CITY OF APPLETON

Date: July 8, 2026
To: City Plan Commission
From: Don Harp, Principal Planner
Subject: Preliminary Plat – Canyon Ridge

A Preliminary Plat of CANYON RIDGE

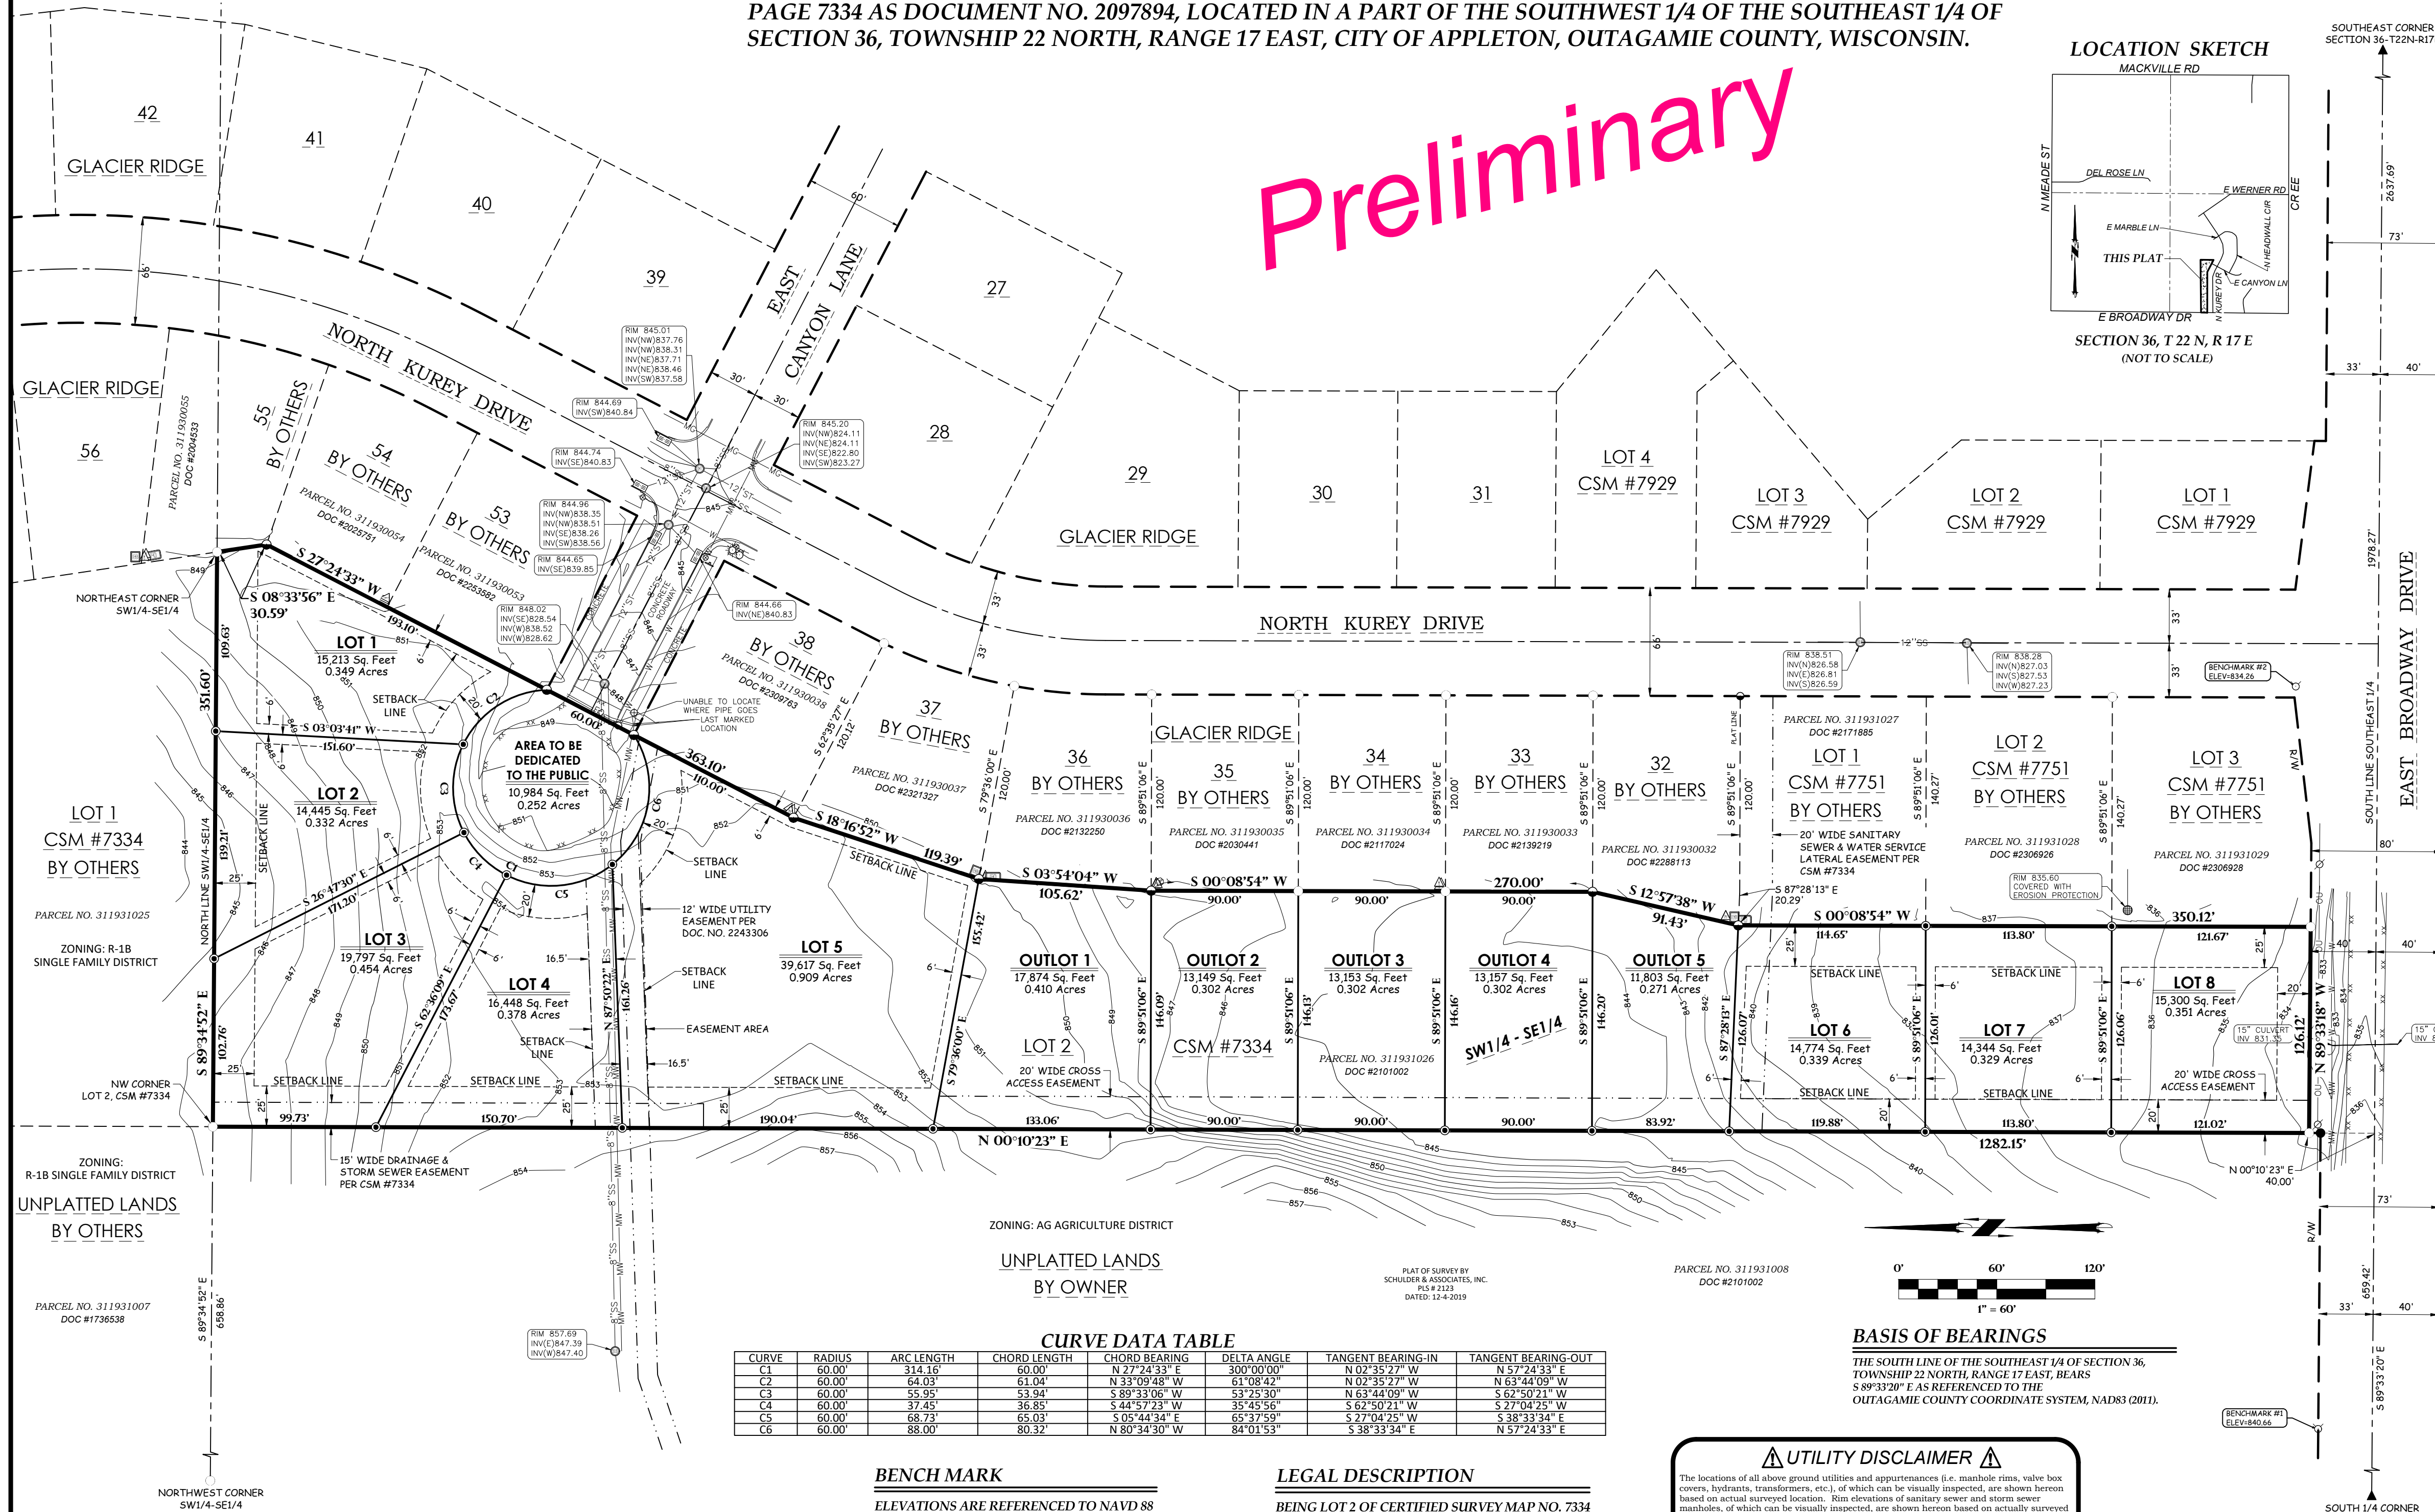
- The property owner proposes to dedicate a public cul-de-sac bulb. As a result, the segment of Canyon Lane located between Lots 38 and 53 of Glacier Ridge will require a street name change. Staff has requested that the owner provide a proposed street name with the Final Plat submittal for review and approval.

The Preliminary Plat for Canyon Ridge, **BE APPROVED** subject to the following conditions and as shown on the attached maps:

1. The Preliminary Plat comments and conditions, including but not limited to, the preliminary plat, street names, drainage plan, engineering plans, traffic, stormwater & environmental, public trail design and grading provided by the Department of Public Works, Engineering Division, Parks and Recreation Department, and Community Development Department dated June 30, 2026 shall be addressed by owner/applicant to the satisfaction of the respective City staff prior to City staff accepting and filing the final plat with the City Clerk's Office.

2. The proposed cul-de-sac street name shall satisfy Section 16-36 of the Municipal Code, the City Street Name Policy and County 911 Service regulations. The final review of the proposed street name recommendation from the City and County GIS staff will occur prior to City signatures being affixed to the Final Plat.
